CASA Ref: F17/7649-51

## TANGARATTA FEEDMILL - CASA (NO) COMMENTS ON AMMENDMENT REQUEST

CASA received a request for advice from NSW Planning. CASA has briefly reviewed the Amendment Request by PSA Consulting for the Tangaratta Feedmill project.

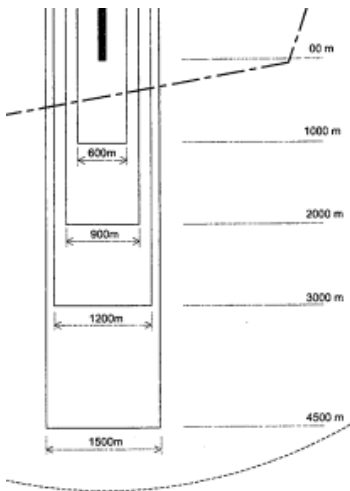
It is expected that there would be more serious bird (the flying type) attractors closer to the airport; for example drains, specific grasses, trees, etc. However, the proposed facility does process bird feed and is not a long way from aircraft Approaches and bird attractors should be avoided.

The system should be 'sealed' as far as practicable so that bird feed is not available to 'opportunistic' birds.

Waste should be stored in closed containers.

Avoid bird perching opportunities where practicable.
